Belsize Fire Station FRA Addendum

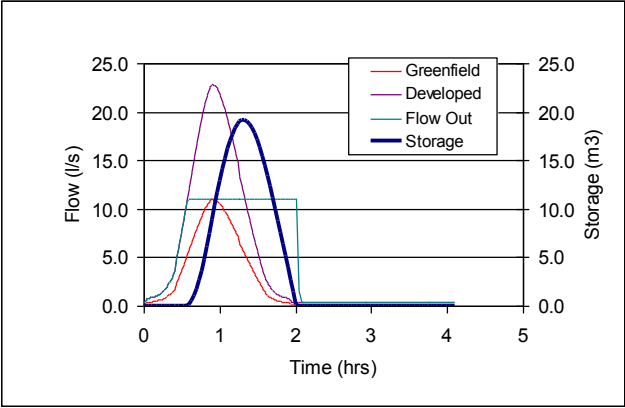
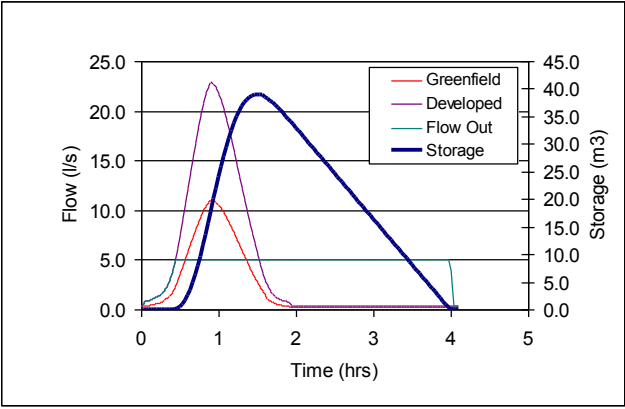
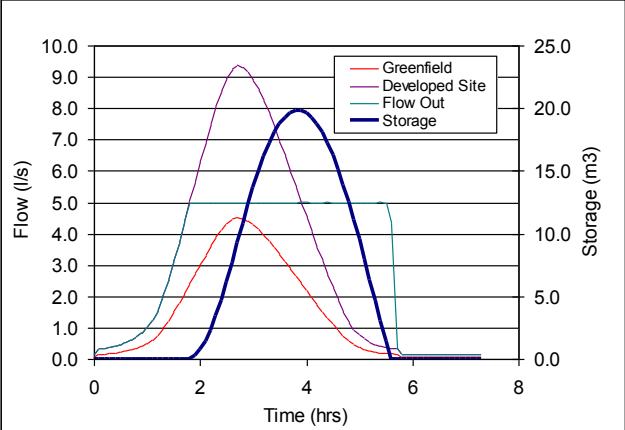
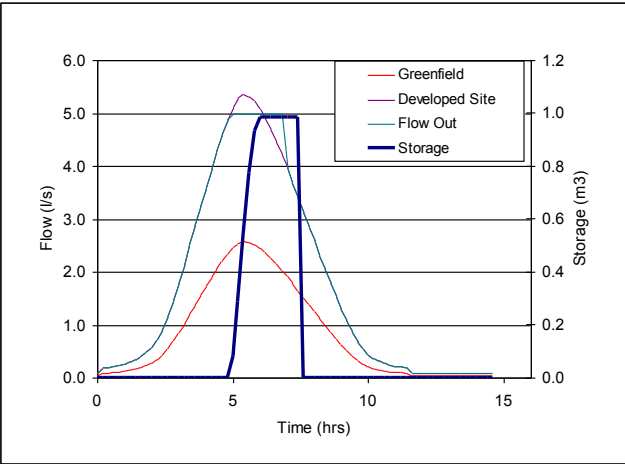
None of these policy documents above specify a storm duration and as rainfall intensity will with storm duration so will the peak flow. It is not enough to state "existing" or "greenfield" as this will require a variable control on any SUDS system depending on the storm duration which cannot be achieved in practice. It is therefore usual to specify a flow release rate for the "critical storm duration" which can then be controlled using a fixed flow control such as a hydrobrake. Using Kirpich's formula the time of entry (T_e) is given as 25 minutes and this represents the time for runoff from an impermeable area to reach the maximum flow. The Wallingford Manual then requires the time of flow through a pipe system (T_f) to be added to T_e to give the time of concentration (T_c). If T_f is taken as the same as the T_e the T_c is then 50 mins which is rounded to give a critical storm duration of 1 hour. However Camden has now advised the 6 hour is required.

The FRA showed that the 1 hour storm on the existing site will provide a peak flow of 16.3 l/s, a greenfield rate of 11.0 l/s and for the developed site with a 40% increase in rainfall (DEFRA guidance of Feb 2016) a peak flow of 22.9 l/s. The 6 hour storm on the existing site gives a peak flow of 3.8 l/s, a greenfield rate of 2.6 l/s and the developed site with a 40% allowance a peak flow of 5.4 l/s.

4. Storage and Attenuation

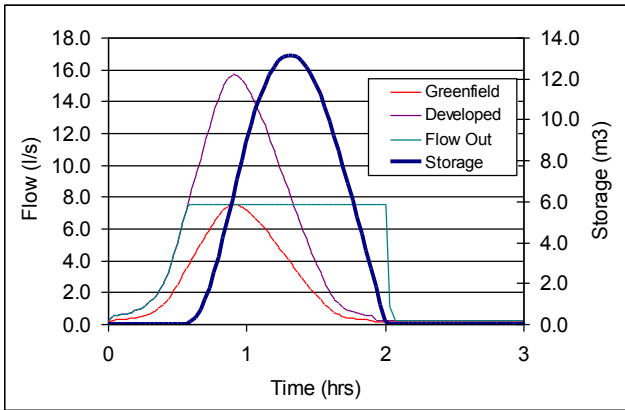
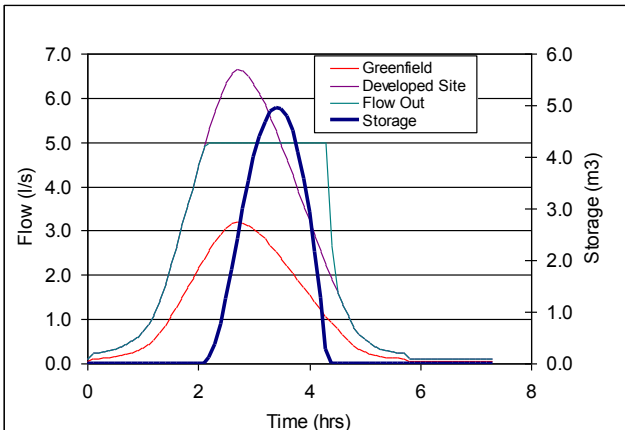
Assuming a typical storm cell is 1.2m wide, 2.4m long, 0.52m deep and with a 95% void space each can provide 1.42m³ of storage. To achieve the 1 hr greenfield rate will then require 14 storm cells over an area of 40m² whilst the greenfield 3 and 6 hour will require fewer storm cells.

The proposals are to use 16 storm cells under the car parking area and this will provide 22.7m³ of storage which is more than enough storage and restrict site runoff for the 1 hour storm to the greenfield rate or the 3 and 6 hour storm to the limiting discharge.
